Re: Defect Information Report FL-509, ZF 8018 Steering Gear Spacer

Defect Information Report
(Section 573.6)

January 2008
FL509A-C
NHTSA #07V-343

Subject: ZF Lenksysteme 8018 Steering Gears

Fig. 1, Data Plate Identification

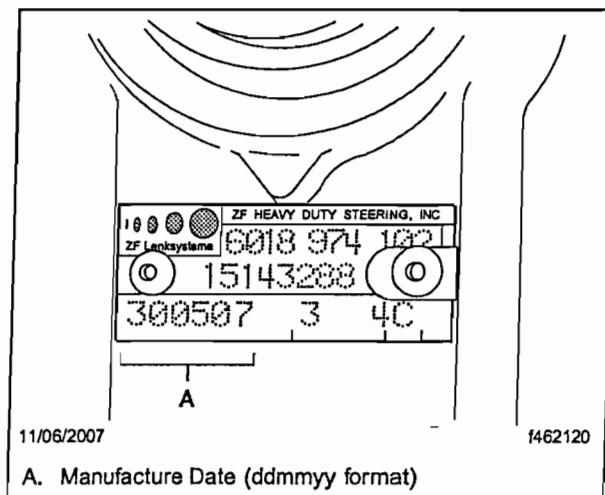
1. Check the base label (Form WAR259) for a completion sticker for FL509 (Form WAR260) indicating this work has been done. The base label is usually located on the front wall under the dash in motorhomes. If a sticker for FL509 is present, nothing further needs to be done. If a sticker is not present, go to the next step.
2. Shut down the engine, set the parking brake, and chock the tires.
3. Check the date code on the data plate of the steering gear. See Fig. 1.
 - 3.1 If the date code is 250407 or more, nothing further needs to be done. Go to step 4.
 - 3.2 If the date code is less than 250407 go to "Steering Gear Replacement."
4. Clean a spot on the base label, write the Recall number, FL509, on a blank completion sticker, and attach it to the base label.
5. Remove the chocks from tires.

Fig. 2, Steering Gear Mounting Bolts

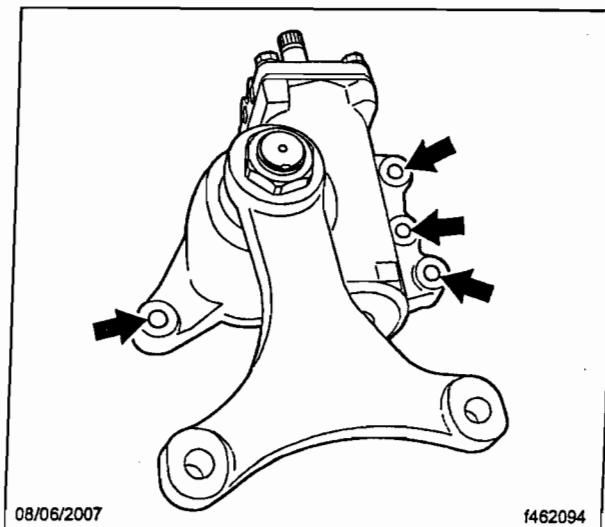
5. Remove the steering gear.
 - 5.1 Using a 1-3/16 impact socket, loosen the four mounting bolts. See Fig. 2.
